- SC Series Bill Validators
- MMI LED Changes

Bulletin #:	FG00206
Bulletin Date:	June 1, 2006
Subject:	MMI LED Changes
Affected Model(s):	All SCXXXX

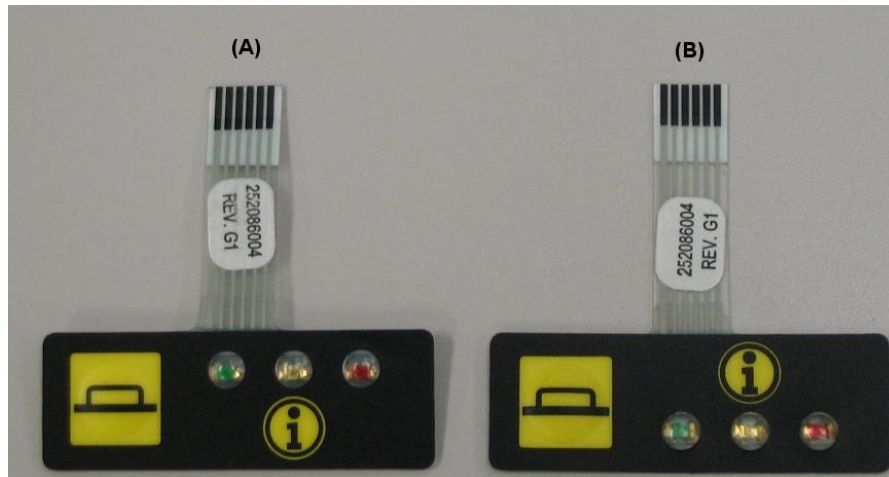
Changes have been made to the MMI's LED board. The LED's have been moved lower and the cable lengthened to reduce the stress at the flex point (See pic. B). **This change does not affect the way the LED's function.**
